APPLICATION NO.	FILING DATE	FIRST NAMED INVENTOR	ATTORNEY DOCKET NO.	CONFIRMATION NO.
10/543,008	07/21/2005	Stefan Huber	112740-1085	2577
29177	7590	05/02/2007		
BELL, BOYD & LLOYD, LLP	EXAMINER			
P.O. BOX 1135	KARACSONY, ROBERT			
CHICAGO, IL 60690				
		ART UNIT	PAPER NUMBER	
		2821		
			MAIL DATE	DELIVERY MODE
			05/02/2007	PAPER

Office Action Summary	Application No.	Applicant(s)
	10/543,008	HUBER ET AL.
	Examiner	Art Unit
	Robert Karacsony	2821

DETAILED ACTION

Fig. 1-OA

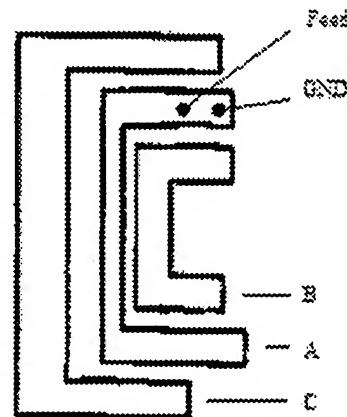
Fig. 1-OA above illustrates one of the multiband antennas of Weinberger illustrated in Fig. 5L using capacitive coupling between the individual radiator elements, as disclosed in Weinberger [0032].

a planar patch antenna (A shown in fig. 1-OA) having a plurality of resonances (the planar patch antenna resonates at a plurality of frequencies) and is further coupled to a ground connection (GND of fig. 1-OA) and to a high-frequency interface (Feed of fig. 1-OA); and a plurality of parasitic transmitters (B and C shown in fig. 1-OA), wherein said transmitters are located marginal to the planar patch antenna (fig. 1-OA) and are each embodied so as to be free of a high-frequency interface (fig. 1-OA), wherein the parasitic transmitters are arranged as line-type conductor structures (fig. 1-OA), whereas the structures of the planar patch antenna are arranged as sheet-type conductor structures (fig. 1OA).

Claim 13: Weinberger teaches at least one parasitic transmitter is provided with a connection to ground (B is coupled to A, which is connected to ground).

Claim 14: Weinberger teaches the plurality of parasitic transmitters are provided with a shared connection to ground (B and C are coupled to A, which is connected to ground, thus, share the connection to ground).

Claim 15: Weinberger teaches at least one parasitic transmitter is free of connections to ground (Fig. 1-OA).

Claim 16: Weinberger teaches the plurality of parasitic transmitters are arranged on opposite sides of the planar patch antenna (Fig. 1-OA).

Claim 17: Weinberger teaches the plurality of parasitic transmitters are located on adjacent sides of the planar patch antenna (Fig. 1-OA).

Claim 18: Weinberger teaches at least one parasitic transmitter extends at least partially over two adjacent sides of the planar patch antenna (Fig. 1-OA).

Claim 19: Weinberger teaches at least one parasitic transmitter extends at least partially over three adjacent sides of the planar patch antenna (Fig. 1-OA).

Claim 21: Weinberger teaches the planar patch antenna and the parasitic transmitters are arranged in a plane (Fig. 1-OA).
